Planning Commission

Regular Meeting Agenda
March 11, 2024 | 6:30 PM
Peachtree City City Hall

SUBJECT: Building Elevations, Taco Bell, 1140 Crosstown Drive

SUBJECT: Landscape Plan, Meditec, 782 HWY 74 S

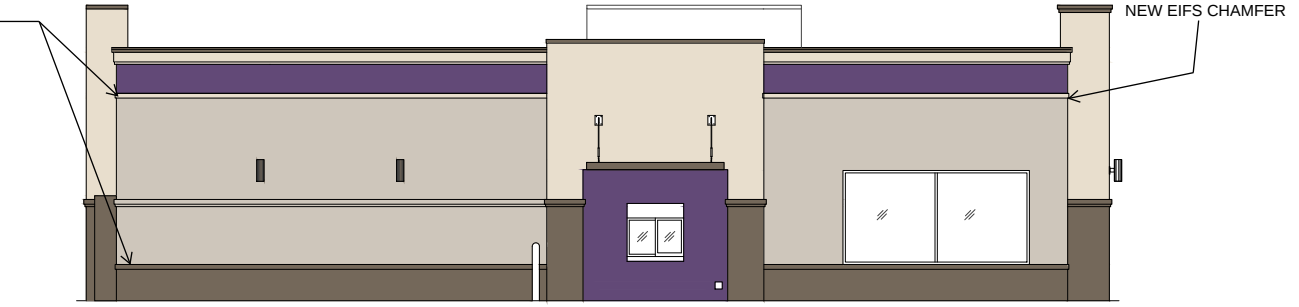
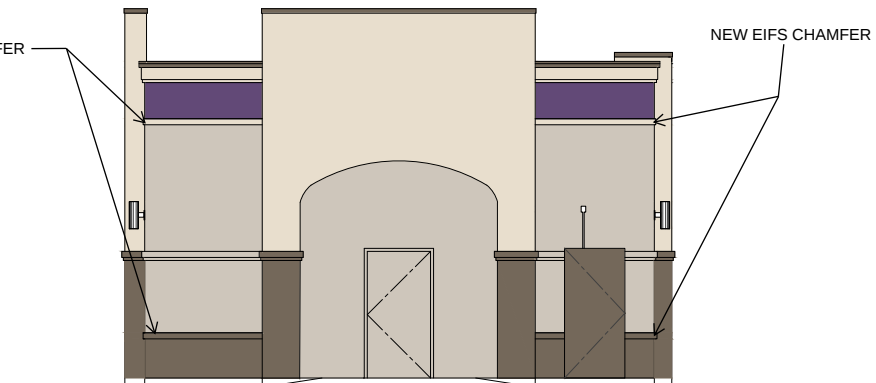
Staff is of the opinion that the proposed primary colors are neutral and complementary to the neighboring buildings. The purple accent color is permitted by Section 730 of the Land Development Ordinance.

The proposed colors for Taco Bell are similar to the existing colors. The ivory color is used on the taller portions of the facade, while a slightly darker gray is used on the rest of the body. The base of the building is grounded with a dark bronze color that is also used on the faux columns. The purple fields over the building entries will remain, and a

purple accent band is proposed around all four sides of the building. In addition, the area surrounding the drive-thru window, which faces Crosstown Dr. and is currently dark brown, is proposed to be purple.

Section 728 of the Land Development Ordinance (LDO) states facade colors should be subtle, neutral, or earth-tone colors and should complement those of neighboring buildings. Staff is of the opinion that the proposed primary colors will blend and be complementary to the surrounding buildings. Section 730 allows for the use of accent colors, such as the proposed purple.

LANDSCAPE PLAN

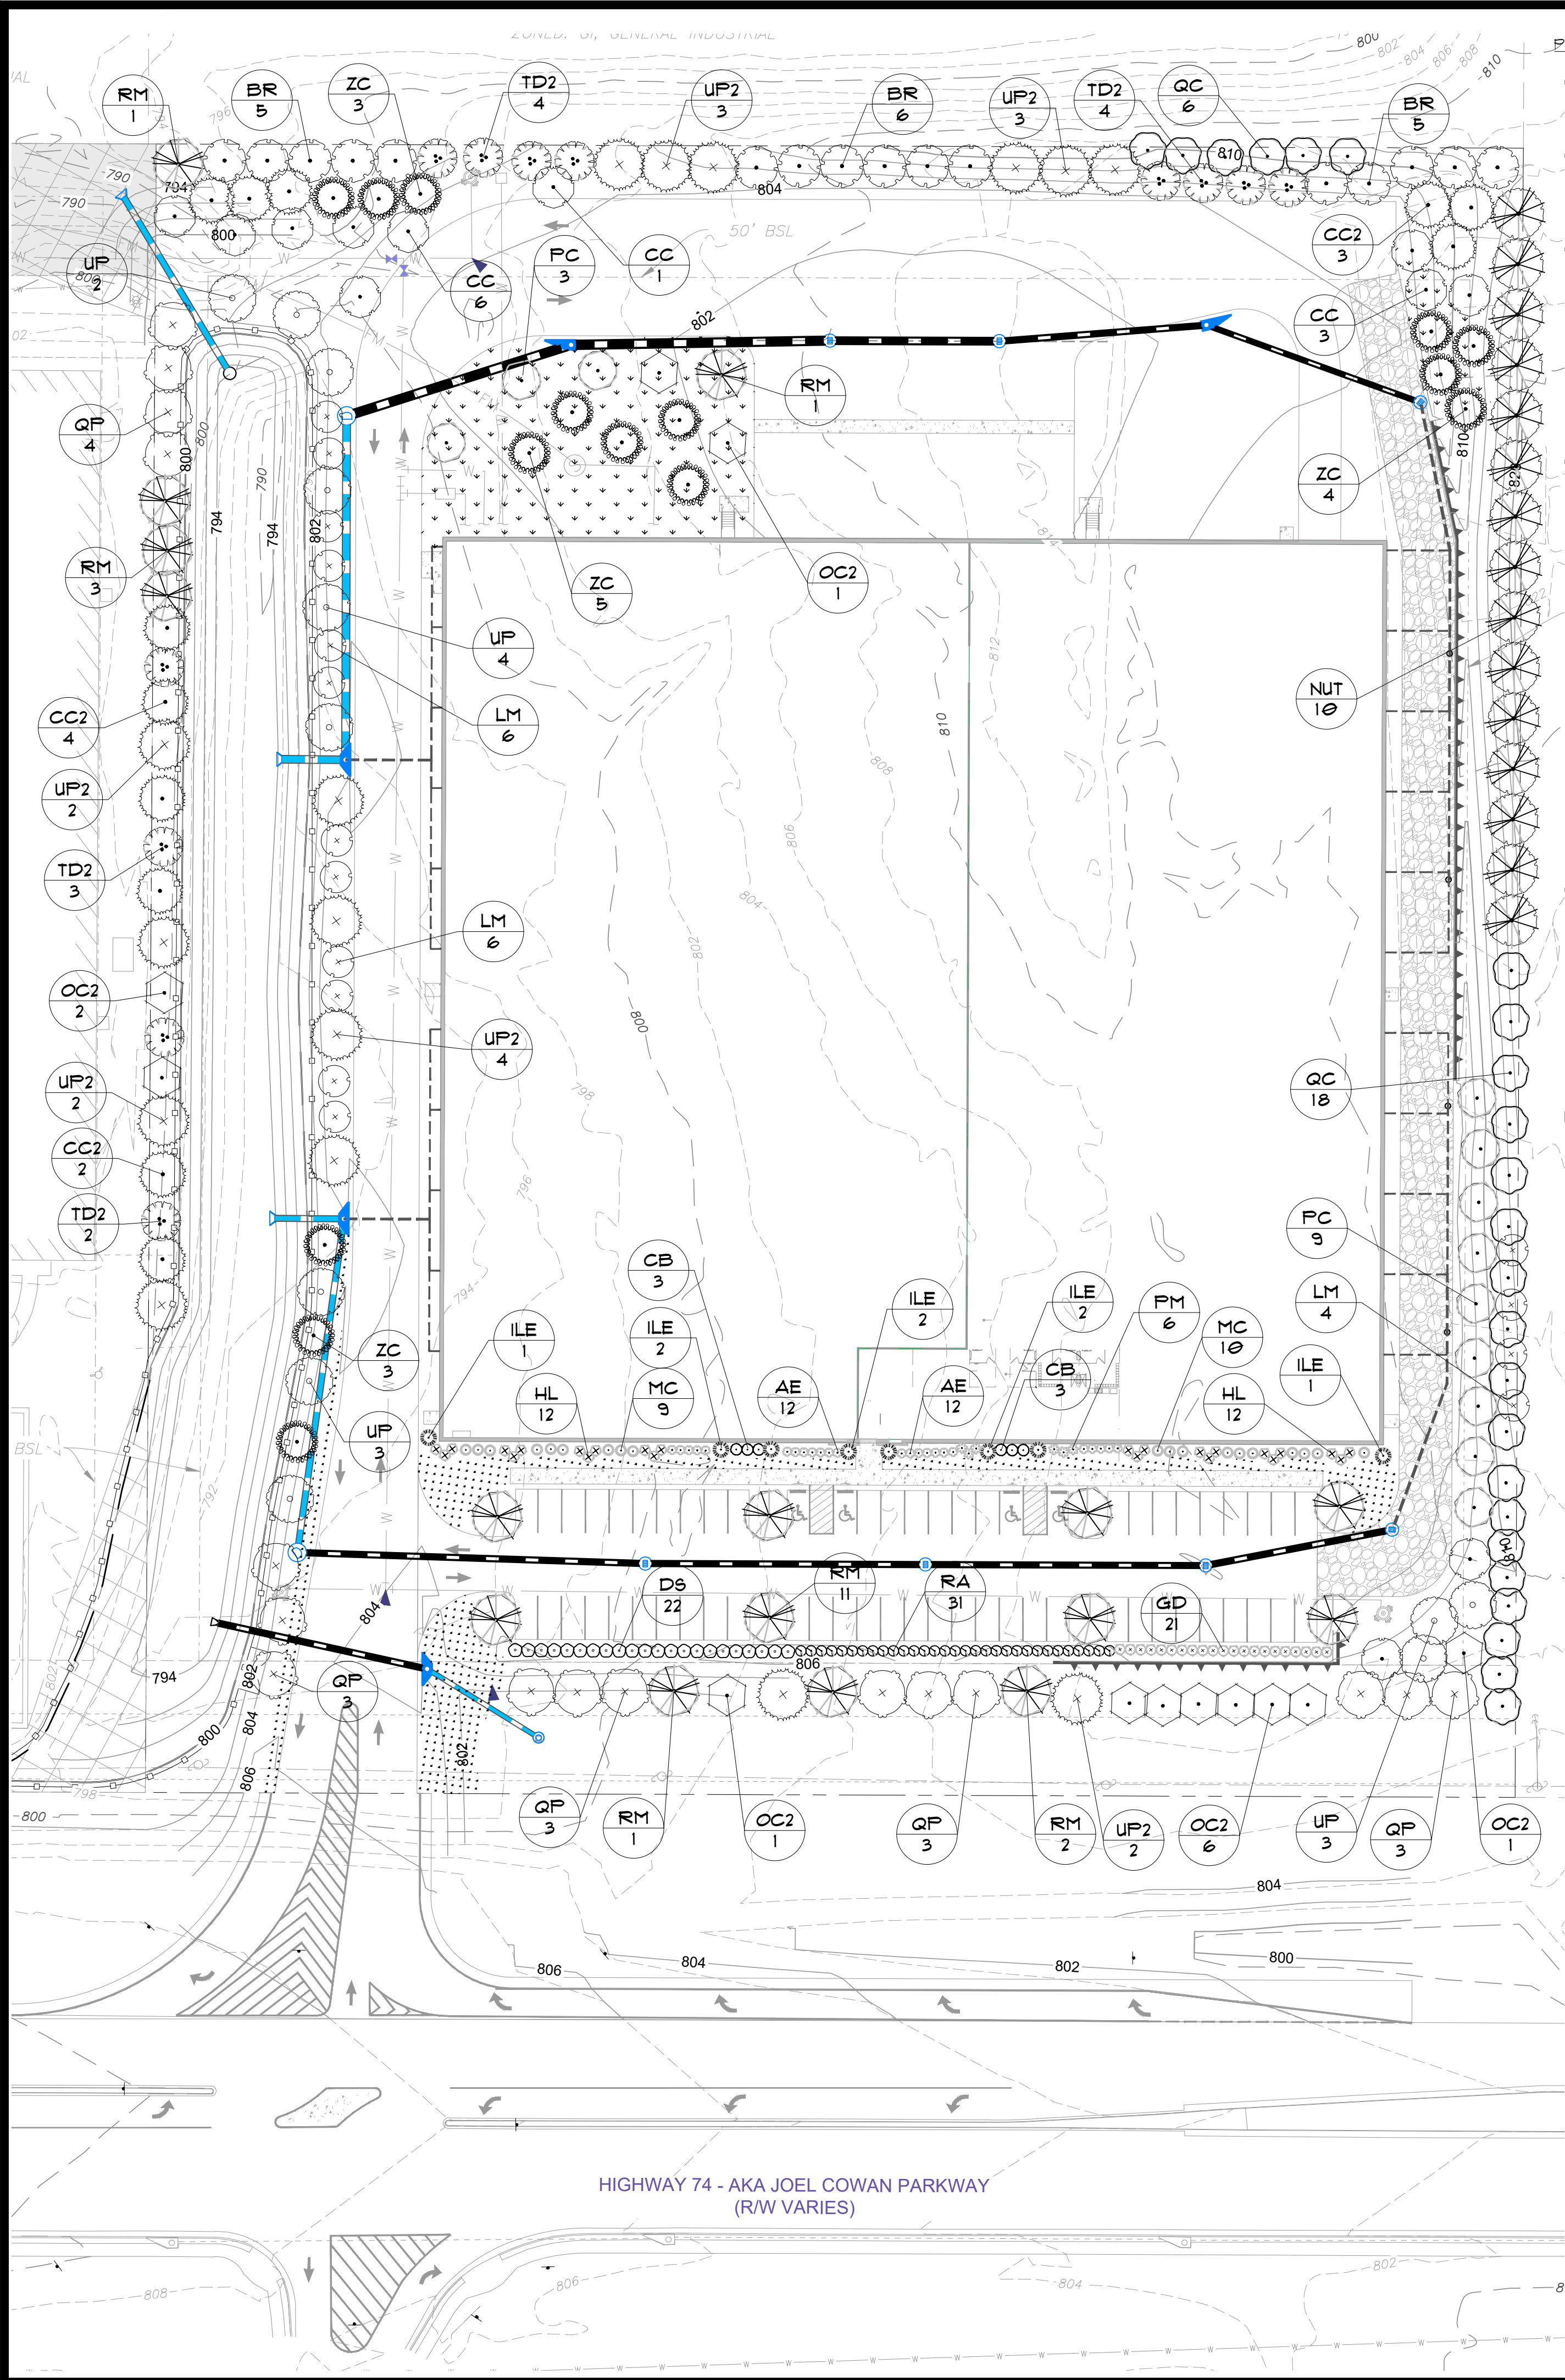
Staff is of the opinion that the proposed landscape plan for the Meditec Manufacturing Facility meets the requirements of the City ordinances using the tree fund alternative compliance method and recommends approval.

Davis Building Company has submitted a landscape plan for the Meditec Manufacturing Facility located at 782 HWY 74 S. During the conceptual site plan process, a 10-foot reduction from the 60-foot tree-save buffer was approved. As a result, the developer is required to install 10% more of the caliper inches of trees required by the landscape ordinance.

Based on the amount of impervious surface on the parcel (187,976 SF), the landscape ordinance requires at least 564 inches of canopy trees and 376 inches of understory trees. With the additional 10% requirement, the caliper inches of canopy trees required increases to 620 inches and caliper inches of understory trees increases to 413 inches.

The applicant is requesting to use the tree fund alternative compliance option permitted in section 1114.5 of the Land Development Ordinance (LDO). Per the ordinance, once all the canopy and understory trees that can be reasonably planted on a project site are provided, the remaining trees can be considered for alternative compliance. No more than 50% of the required caliper inches of canopy and understory trees can be met using this alternative compliance method. It is the opinion of Staff that the project site has been designed to be planted to its fullest capacity and meets the caliper inch requirement using the tree fund alternative compliance method (see table below).

Per section 1108 of the LDO, the perimeter of all parking lots shall be landscaped with evergreen plant material that is a minimum of 24 inches in height at the time of planting. The Gardenia, Indian Hawthorn, and Distylium proposed next to the parking area that faces HWY 74 are evergreen, and it is noted in the remarks that the plants must be a minimum of 2 feet in height at planting, which meets the requirement.
